Duquesne Light

SUBJECT: Beaver Valley Power Station - Unit No. 2
Docket No. 50-412
FSAR Environmental and Hydrologic Engineering Branch Questions

Attached to this letter are Duquesne Light Company's (DLC) responses to the Environmental Hydrologic Engineering Branch (EHEB) questions (240.12-240.16) forwarded to DLC in you letter dated October 12, 1984, received October 18, 1984, and SER Open Item Nos. 1 and 2. These are also provided in response to the EHEB questions (240.1, 240.2, 240.4, 240.6, 240.7, and 240.8, dated August 13, 1983) in which the staff required revised information using Hydrometeorology Reports 51 and 52. It is DLC's understanding that responses to the above EHEB questions are now complete. These responses will be incorporated into the next FSAR amendment.

Figure 240.15-4. Peggs Run PMF Water Surface Elevation,
 Floodway west of Rt. 168

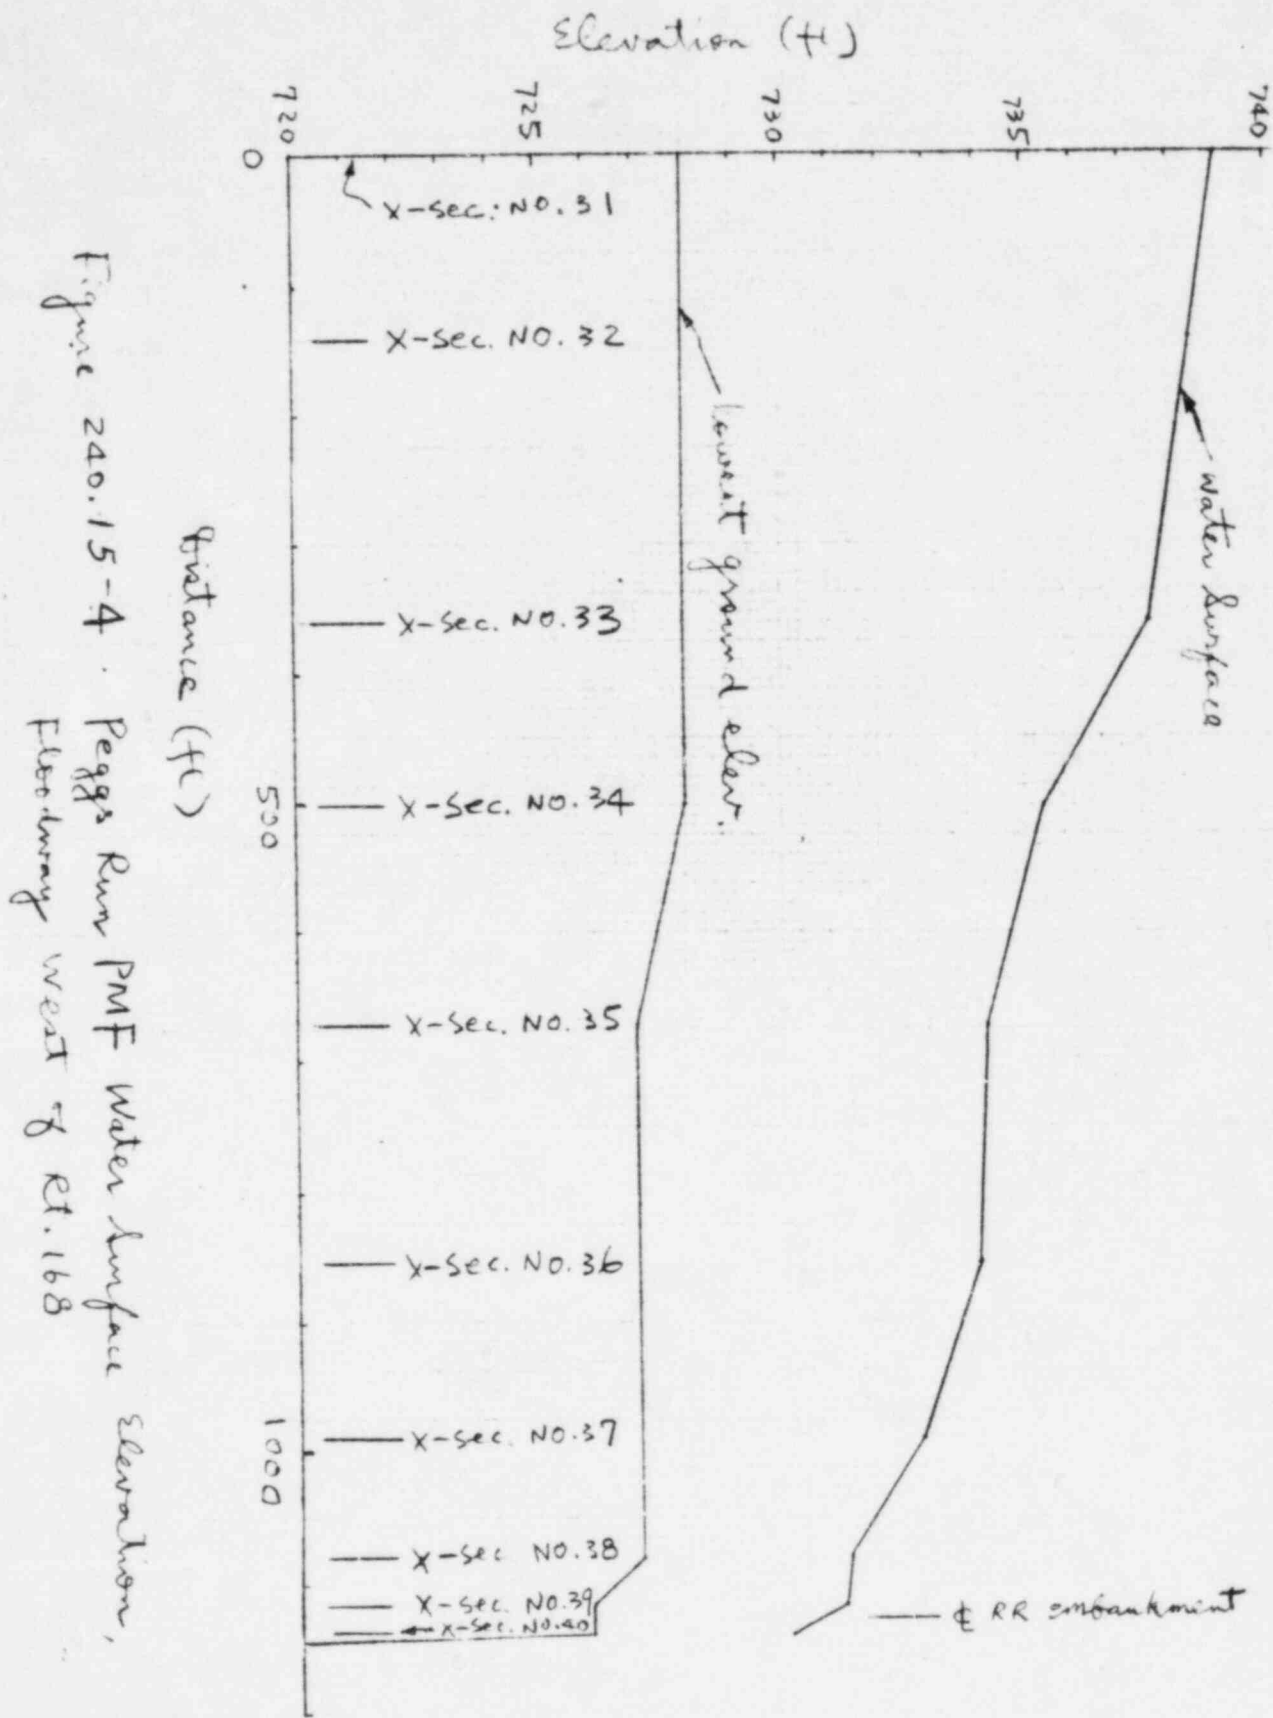
You state that you determined that, if the Peggs Run culvert failed during a PMF such that it would carry only negligible flow, due to blockage by debris, water levels in the vicinity of safety related structures would be below an elevation of 730 ft. What elevation did you calculate? You further state that the U.S. Army Corps of Engineers water surface profiles program HEC-2, was used to generate a series of water surface elevations. Please provide those elevations together with the cross-sections used and their locations. Also provide all pertinent values such as Mannings "n" values, flows, starting water levels, slopes, and any other assumptions used in computing water surface profiles. If you determined that water would overflow Peggs Run to the area east and south of the Highway 168 bridge approach, provide a detailed topographic map of this area.

The division of the PMF flow by Route 168 near the turning point of Route 168 was evaluated for various flow rates using the U.S. Corps of Engineers' water surface profile HEC-2 program (1979). The calculation started from downstream control sections with critical depth and was carried upstream. By matching the water surface elevation from both channels at the point where the two channels join together with a combined discharge equal to 17,000 cfs, the flow rate for each channel was determined. Mannings 'n' values of 0.04 on the floodway channel and 0.05 on the overbank were used. The topography and cross-section locations are shown on Figure 240.15-1. Cross-section plots for the west and east channels are shown on Figures 240.15-2 and 240.15-3, respectively. HEC-2 input data for the west and east channels are presented in Tables 240.15-1 and 240.15-2, respectively. The water surface profile for the channel west of Route 168 is shown on Figure 240.15-4.

As shown on Figure 240.15-1, all safety related structures are located away from the Peggs Run floodway, and downstream of the railroad embankment. The water surface elevation at cross-section 40, at the railroad embankment, is 730.07 ft msl

(Figure 420.15-4). The floodway drops sharply downstream of cross-section 40 and the water elevation there will be below 730 ft msl. Safety related structures will not be impacted by Peggs Run flooding since minimum plant finished grade is 730 ft-4 in. (FSAR Section 3.4).
